Radio Frequency Analysis Report

Site MA-4388

196 West Street
Paxton, MA 01612

May 9, 2014

Exhibit 16: Normalized CW Drive Test @ 134' and Predicted Coverage

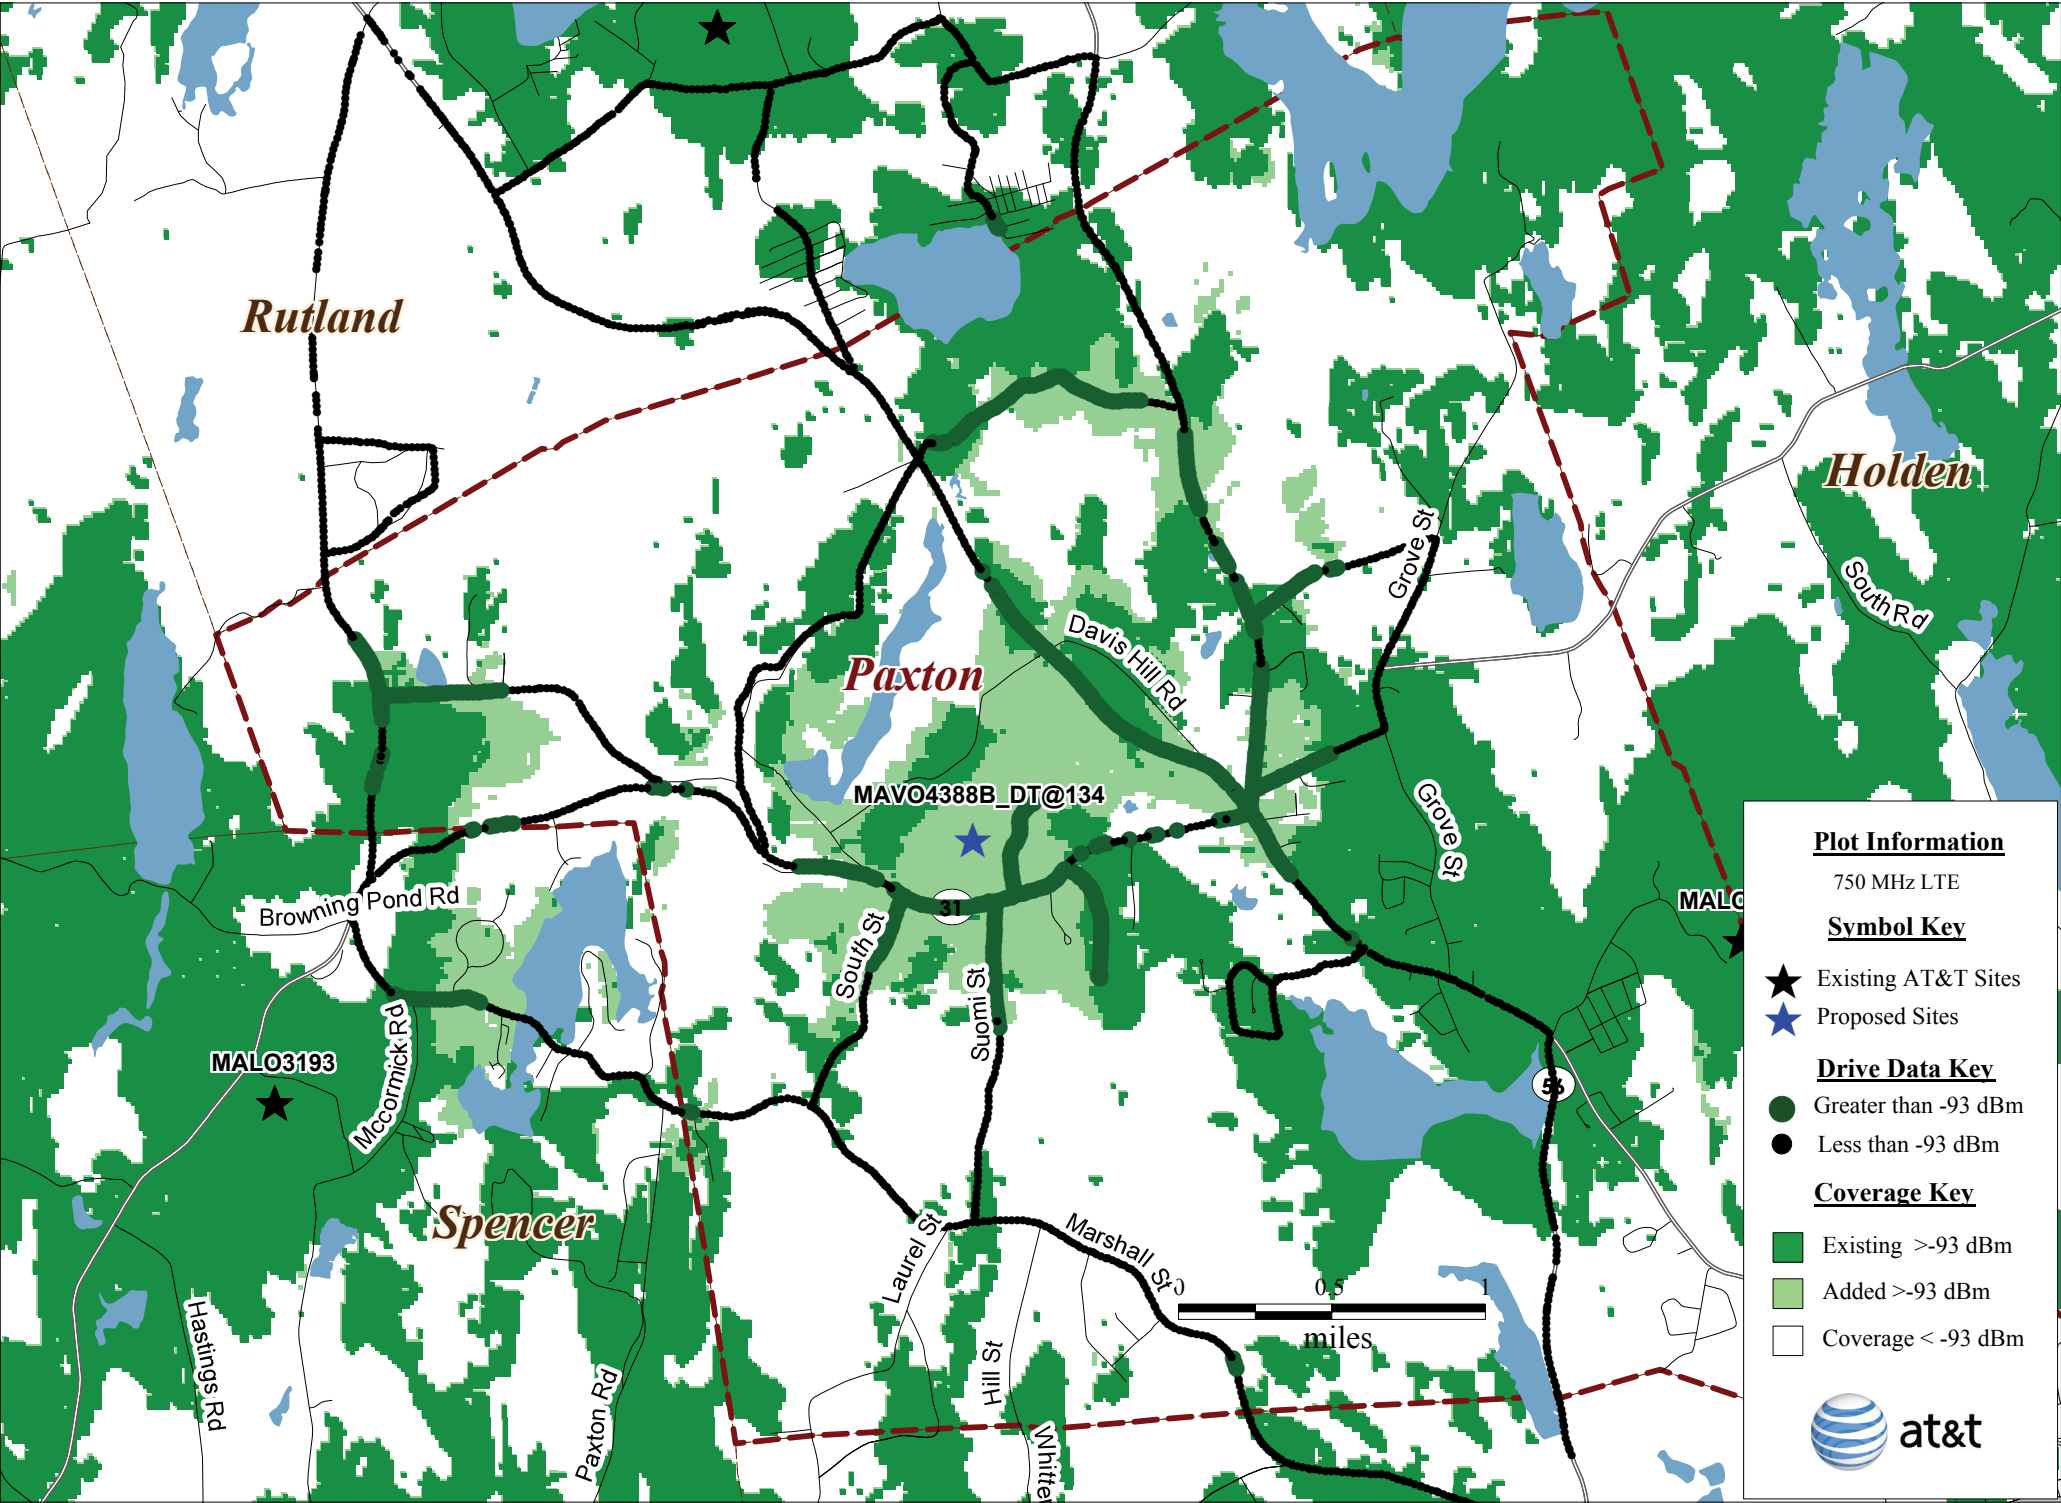
- Exhibit 16 titled: “Normalized CW Drive Test @ 134' and Predicted Coverage” was requested by Mr. Graiff. The original drive test data maps provided at Exhibits 13, 14, and 15 are unaltered data from the CW drive test and show the measured received signal strengths. However, because by necessity a CW test does not use the exact antenna model that will be installed, there can be slight differences between the coverage from the CW test and the coverage provided from the actual antenna to be used. Therefore, the data can be “normalized” or corrected by the prediction tool to depict coverage based on the actual antenna model to be used by AT&T.
